REMARKS

Enclosed herewith is a Request for a Continued Prosecution Application under 37 CFR 1.53(d).

FIG.4

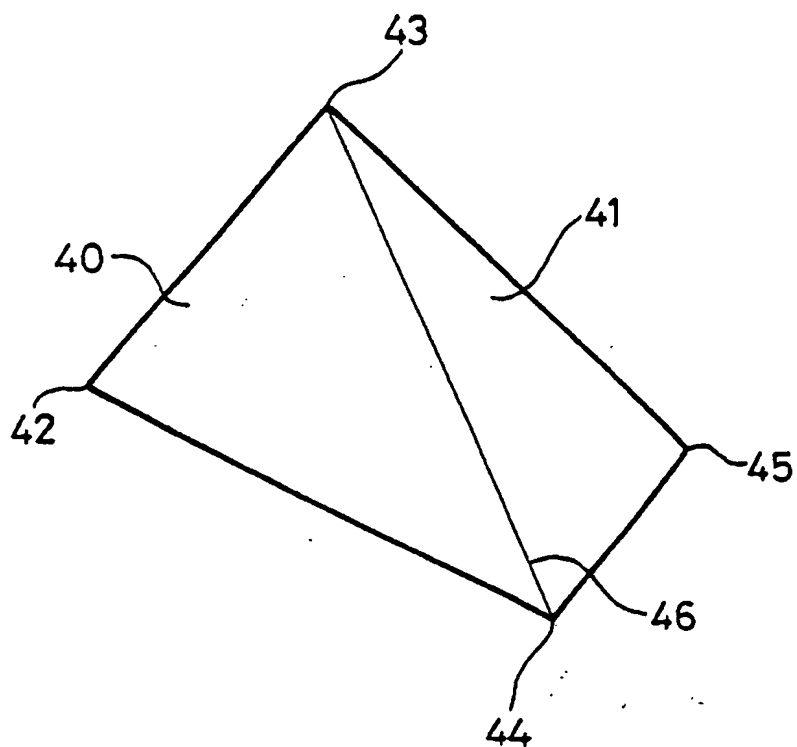
Attached to this amendment, is a marked copy of Figure 5 of the present application. In the first full paragraph of page 4 of the Examiner's Office Action, the Examiner questions the numbering of the lines. The Examiner is correct. The facet 40 of Figure 4 is defined by the points 42, 43, and 44 while the facet 41 is defined by the points 43, 44 and 45. In Figure 5 where a new rank point 47 is provided, it is evident that the facets labeled 40 and 41 in Figure 5 do not correspond to the similarly numbered facets in Figure 4. That is, the facet 40 in Figure 5 is defined by the points 42, 44 and 47 while the facet numbered 41 in Figure 5 is defined by the points of 43, 45 and 47. Accordingly, with the submitted drawing of Figure 5, these facet numbers have been changed to 40' and 41' respectively. This would indicate that facet 40' has some commonality with facet 40, namely, the segment defined by points 42 and 44. Similarly, the facet 41' has commonality with facet 41, namely, the segment defined by points 43 and 45.

Applicants then explain the three-dimensional procedure with respect to Figure 4 and 5. Again, the Examiner should take into consideration that the operator carrying out this method has at his disposal a plurality of images which may be sections taken through the object at several different positions. The method can be performed for each or any of the plurality of images to achieve by iteration an acceptable approximation of volume in three-dimension. It is evident that the point 47 is another point on the surface of the object in the same manner as the points 29, 30 or 31 are further points on the contour 20 in Figure 3.

It is hoped that these changes will be satisfactory for the Examiner's purposes. Changes have been made in page 6 of the specification to account for the change in numbering.
